Technical Service Bulletin

January 4, 2018

Piston Kits for CX50 for Venom Engine
TSB0518

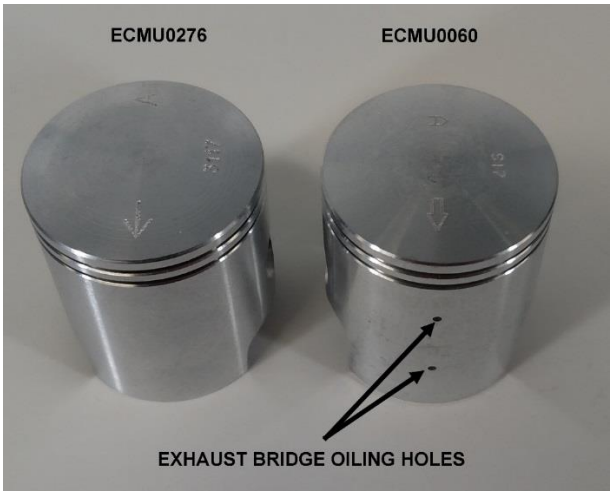
Cobra is releasing new pistons for the CX50 Venom Engine. The new piston does not have the two oiling holes on the exhaust side. This will impact

ECMU0060 pistons will work in old and new engines as they have for years. ECMU0276 pistons will NOT work in the old engines with bridged exhaust.

The rings, although visibly different (letters on the top surface), are interchangeable from piston to piston and model to model. The shape and material of the rings are equivalent. Wrist pins and “C” clips are also interchangeable.

Description	Old Part Number	New Part Number for Venom
Piston kit	ECMU0060 (A, B, C etc…)	ECMU0276 (A, B, C etc..)
